VARLEY STREET, SEN SCHOOL

ATTENUATION TANK

DETAILS OF ATTENUATION/STORAGE
TANK DETAILS USING POLYSTORM
PSM1A UNIT.

Subject: RE: Attenuation Tank Proposal

Scale	Drawn	Checked
N.T.S.	AY	KD
Date	Drawing No.	Revision
19/08/2024	PSM - 2.4	R0

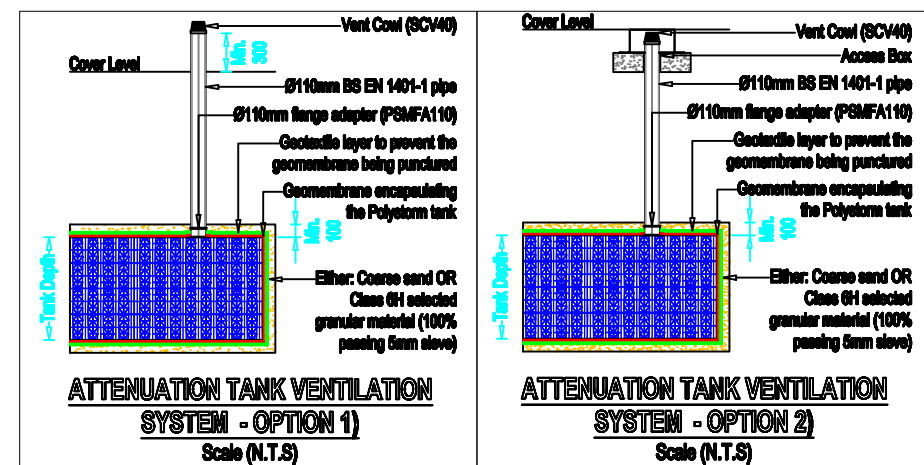
They have calculated that your design provides 615m³ nett when including the stone trench. Calculation is below:

Crates 32m x 16.5m x 1.2m x 0.95	601.92m ³ nett
32m x 300mm slotted pipe (OD 3.08m ³)	2.26m ³ nett
Stone 32m x 1m x 1.2m less 3.08m ³ x 0.3	<u>10.60m³ nett</u>
	614.78m³ nett (91.49% void)

- Provide just 615m³ nett as per Ridge's design.
- Polystorm PSM1A
- 36.00m x 15.00m x 1.20m = 648.00m³ gross x 0.95 = 615.6m³ nett.
- Complete with a 36.00m run of PSM4 Inspect modules

I have spoken to Jack at CGC this morning with regards to the SW tank detail. The SW tank currently has an IL of 57.780mAOD and the upstream SW1.09 IL is 57.585mAOD (as built IL). To remove the Stone trench and replace with the Polystorm product that you would like to use, the proposed SW tank would need to be lowered (approximately by 300mm to IL of 57.480mAOD).

The supplier proposes utilising these modules instead of the stone trench, as it provides a channel similar to the perforated pipe shown on Ridge's design.

Essentially, we would install the already approved PSM1A crates for the majority of the tank and install a row of PSM4 crates in place of the perforated pipe and stone trench.

The SW tank volume as per the SW GA's and SW Tank Detail is **638m3**.

We will lower the SW Tank as per the recent correspondences and update the drawings to match this.

The Stone trench can be removed and the polystorm product can be introduced.

Please note that there is permeable surfacing above the proposed SW tank area and the adaptor from the type 3 subbase to the SW tank is still required.
